Office Action Summary	Application No. 10/563,354	Applicant(s) SCHANZ ET AL.	
	Examiner KATHERINE ZALASKY	Art Unit 1797

DETAILED ACTION

2. **Claims 1-19** are rejected under 35 U.S.C. 103(a) as being unpatentable over Hemming ("10.3 Liquid-Liquid Extraction (Solvent Extraction)") in view of Ehrfeld et al. (US 2003/0039169).

Fig. 3a)

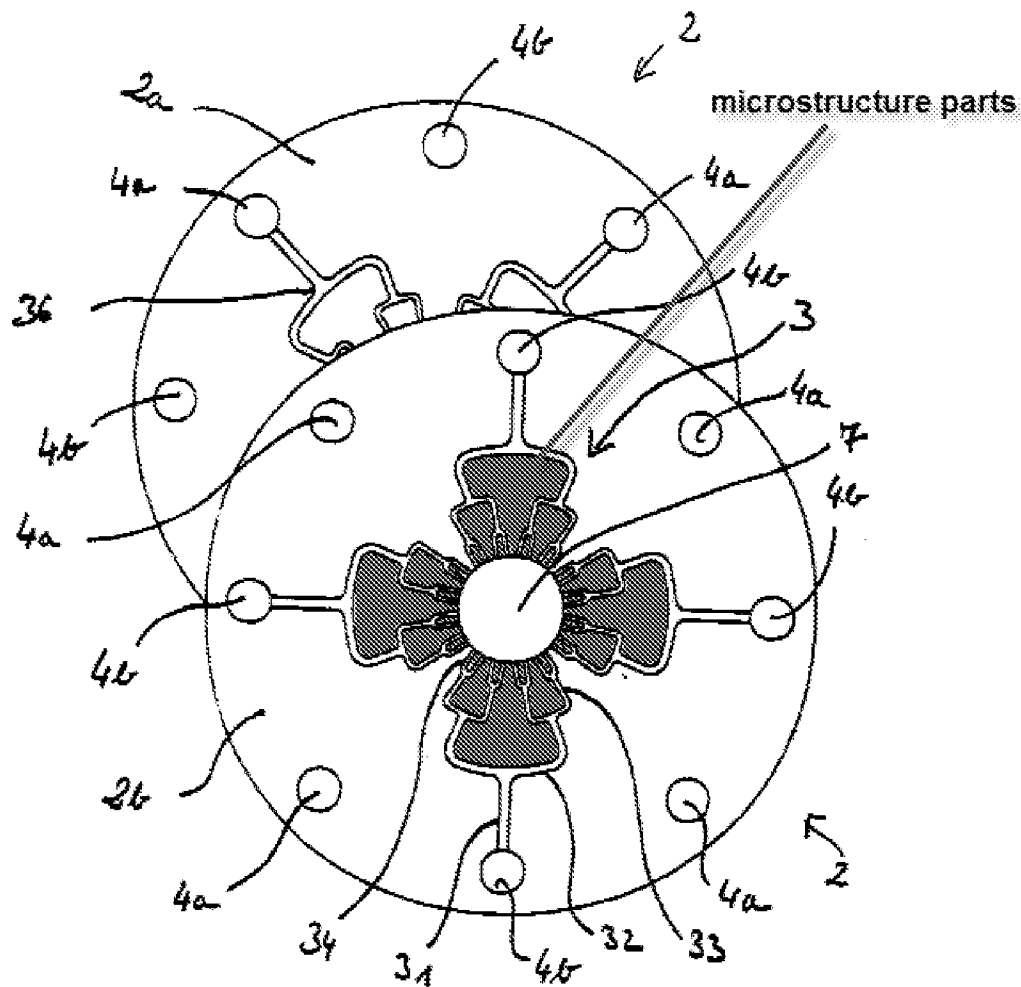
- said linking channel is divided into two or more part channels by microstructure units immediately before opening into the mixing zone, and each of the part channels has a respective width in a millimeter to sub--millimeter range that is smaller than the width of the mixing zone (Figure 3a, [0051], microchannel 31, 32, 33, 34, opening 7)
- said microstructure units are in contact with said mixing zone (Figure 3a, see annotation below, every shaded microstructure part is in contact with the mixing zone)

In Ehrfeld, the linking channel (microchannel 31) is divided into two or more part channels (microchannels 32, 33, 34) by microstructure units (as labeled above on annotated figure 3a) immediately before opening into the mixing zone (mixing zone formed by opening 7, microchannels 34 empty directly into this mixing zone).

Alternatively, in Ehrfeld the linking channels (microchannels 33) are divided into two or more part channels (microchannels 34) by microstructure units (as labeled above on annotated figure 3a) immediately before opening into the mixing zone (mixing zone formed by opening 7, microchannels 34 empty directly into this mixing zone).
